TOWN OF COLCHESTER
APPLICATION FOR
FINAL PLAT REVIEW

- 5) PROJECT STREET ADDRESS: 242 Severance Road
- 6) TAX MAP & PARCEL #(can be obtained at Assessor's Office) Tax Map 4, Parcels 30-1, 30-2, 30-3, 30-5, 30-6, 30-7, 30-8, 30-9, 30-10, 30-11, 30-12, 30-13

- 7) PROJECT DESCRIPTION
 - a) Please note if new lots are being created and whether or not the request is for a regular subdivision, planned residential development, or planned unit development: _____
This application is for a planned unit Development that will create new lots.

IRELAND INDUSTRIES SUNDERLAND FARMS COMMUNITY

SEWER AND ELECTRICAL DETAILS

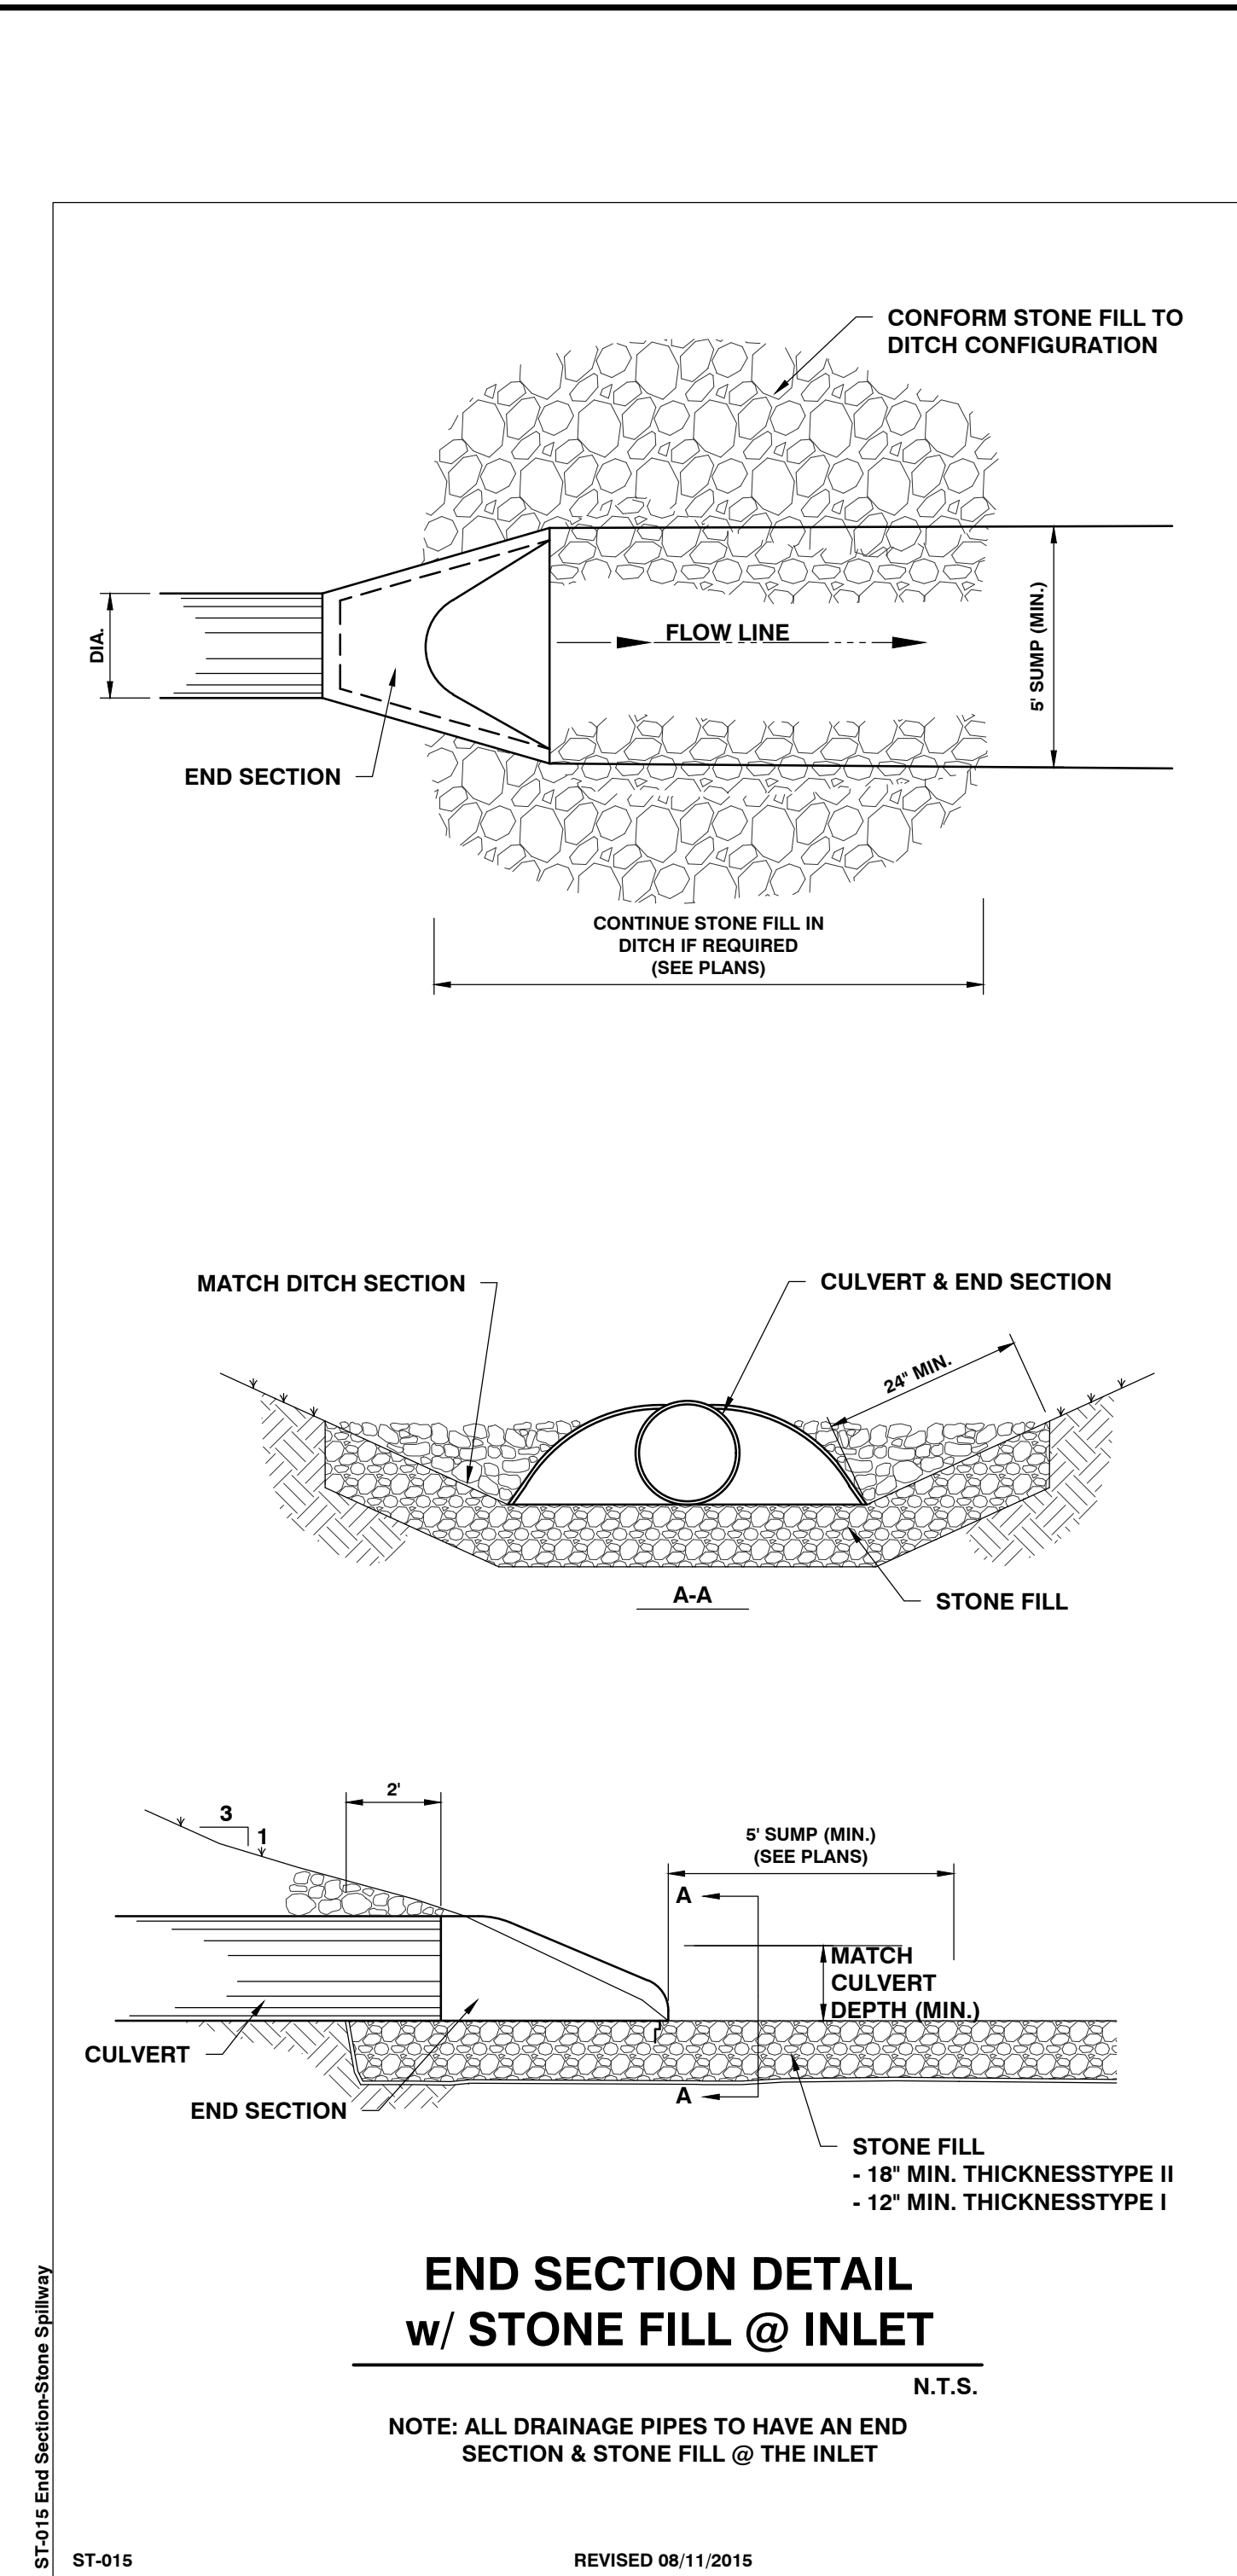
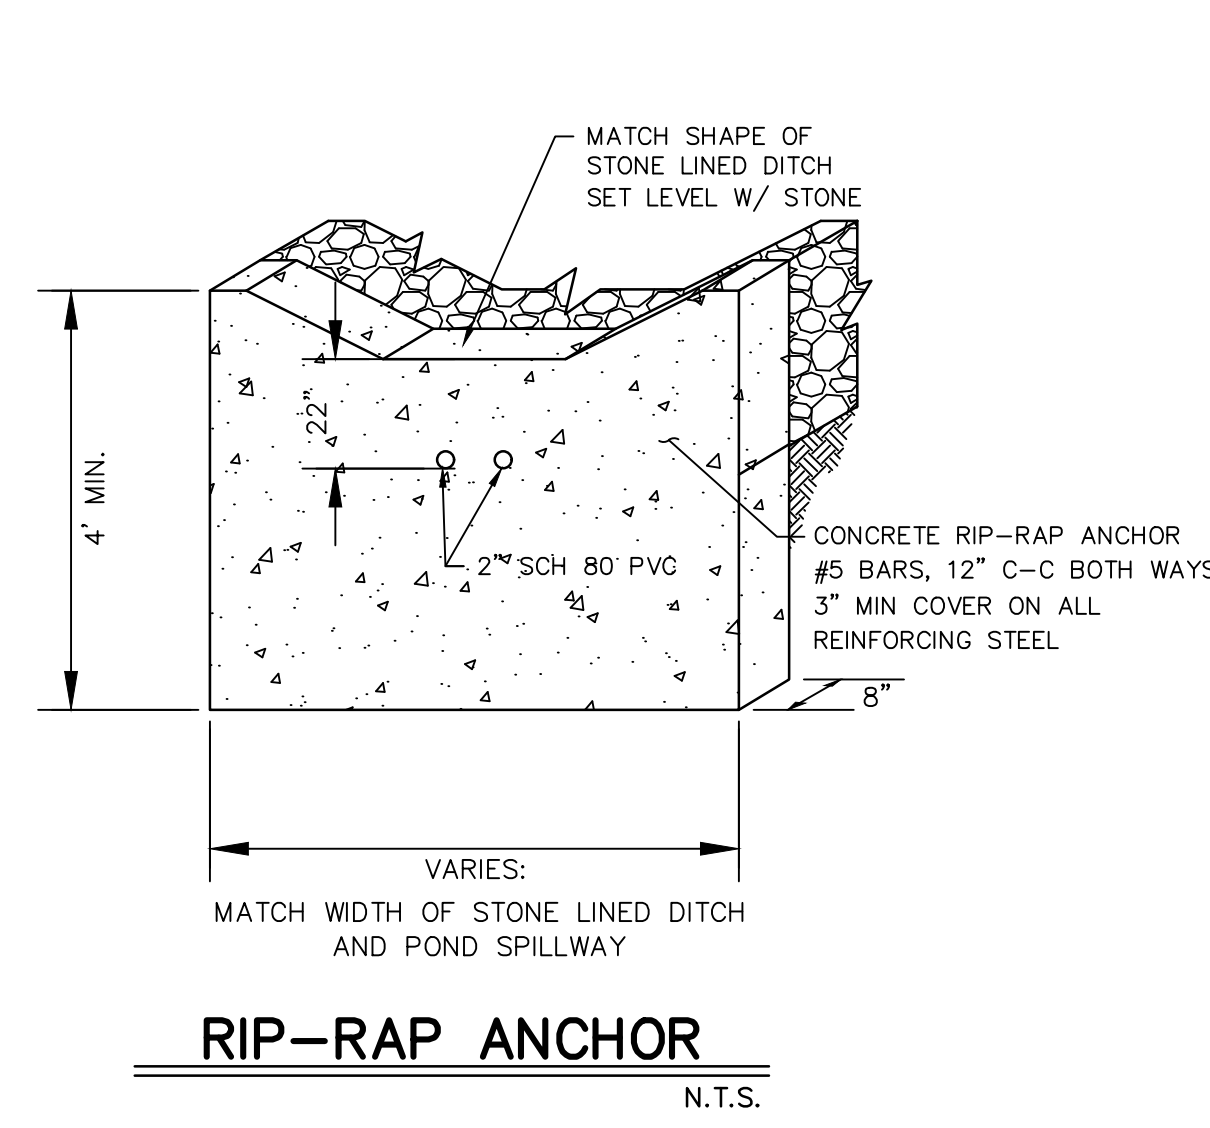
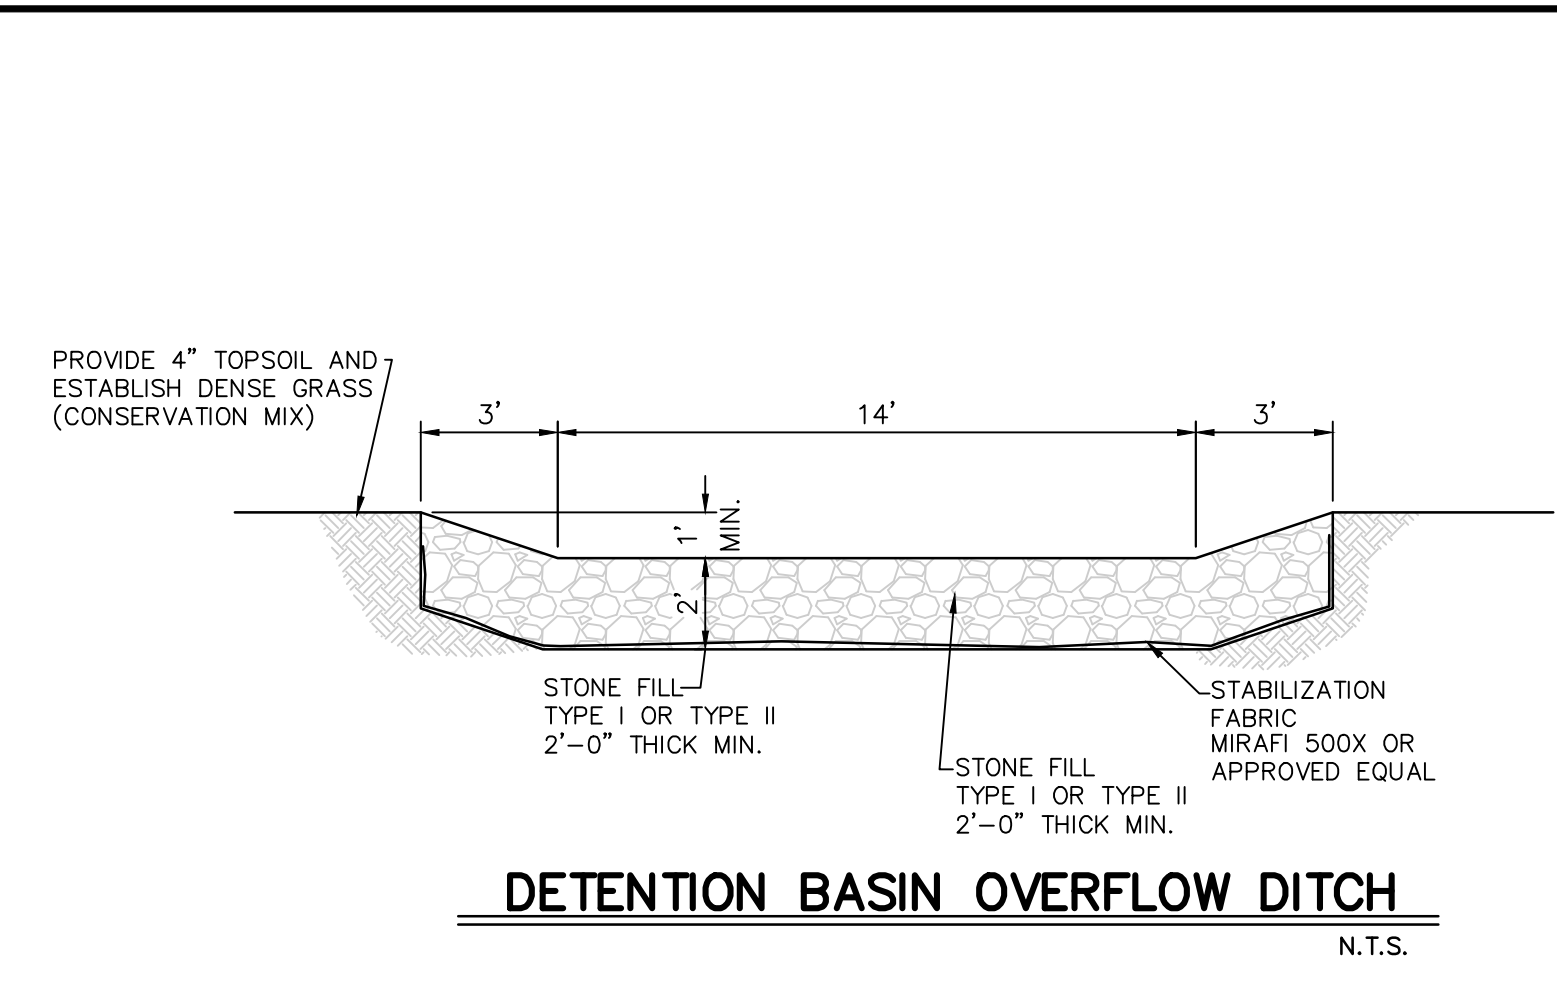
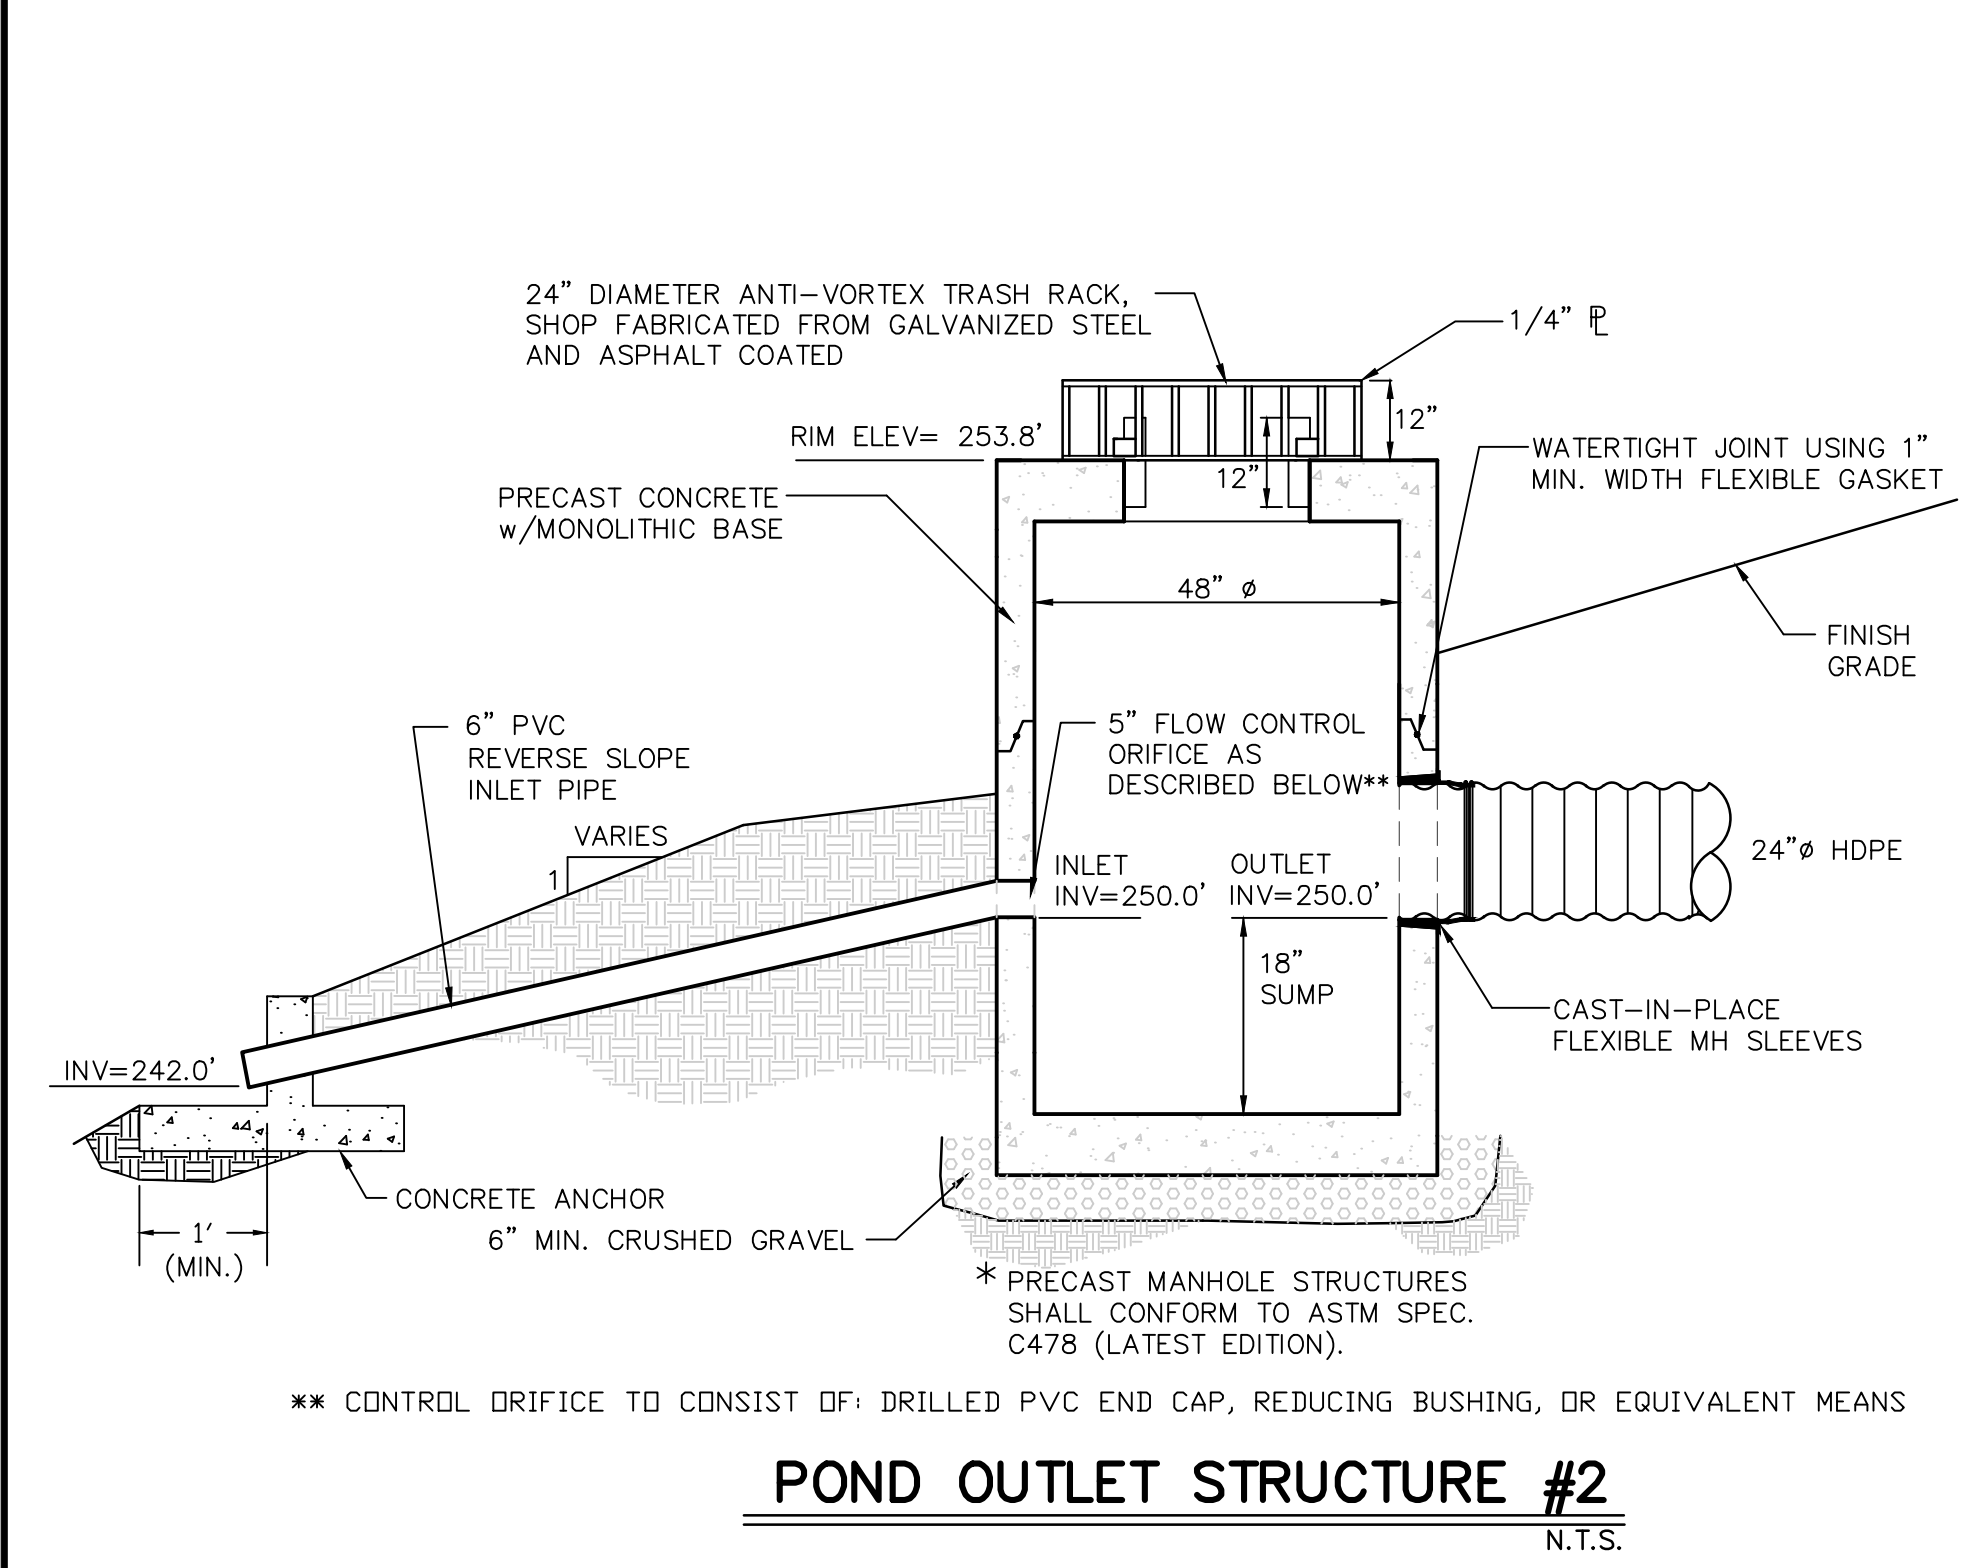
- f. Provide electrical plans including wiring layout with power supply stanchion (meter base and shutoff) and all necessary conduit and junction boxes. Include overlapping easement areas for Town and Utility at metering location. **The proposed secondary wiring layout is shown on Sheet C3.5-Electrical Layout Plan. The details for the power board/meter/disconnect is shown on Sheet C5.0-Sewer & Electrical Details.**
